- Subject** ▶ Changes on blade case, etc.
- For Models** ▶ 5143R(355mm Circular Saw)
- Note** ▶ This information applies to European countries.
- Description** ▶ As described below, six parts have been changed for less rickety.

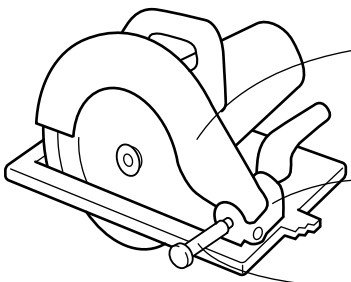
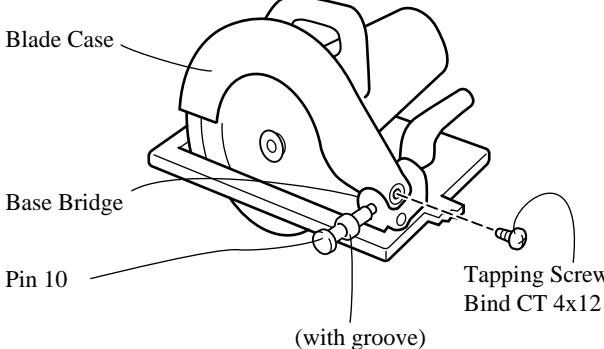
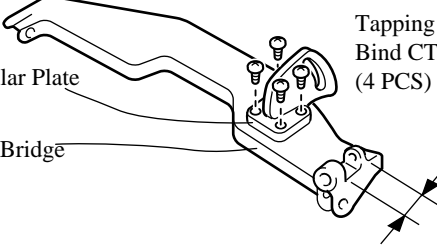
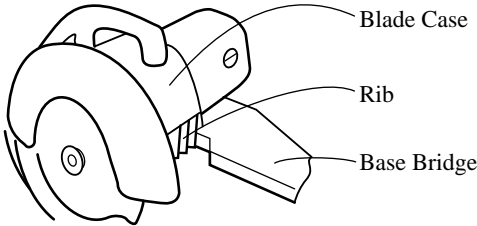
CURRENT	NEW
Tapping Screw Bind CT 4X12		 Blade Case and Pin 10 are fixed by tapping screw, so that they become less rickety.
Pin 10		Tolerance is changed to make the gap between Pin 10 and Base Bridge narrower.
Tapping Screw Bind CT 5X20		 Number of tapping screws fixing Base Bridge and Angular Plate ; 2 => 4
Base Bridge		Make the gap between Base bridge and Blade Case narrower.
Blade Case		Rib which contacts with Base Bridge is added to Blade Case.

Item No.	Current part		Q'ty	I/C	New part		Q'ty	Note
51	Blade Case Complete 152497-0		1	<=	Blade Case Complete 152546-3		1	The current can be used for 5103R Interchangeable as a set
60	Pin 10 268008-2		1	<=	Pin 10 268018-9		1	
55					Tapping Screw CT4x12 266026-4		1	
93	Angular Plate 316746-1		1	<=	Angular Plate 316879-2		1	The new is fixed with two screws when either of the currents is replaced.
101	Base Bridge 316750-0		1	<=	Base Bridge 316880-7		1	
69	Tapping Screw Bind CT5x20 266036-1		2	Yes	Tapping Screw CT5x20 266036-1		4
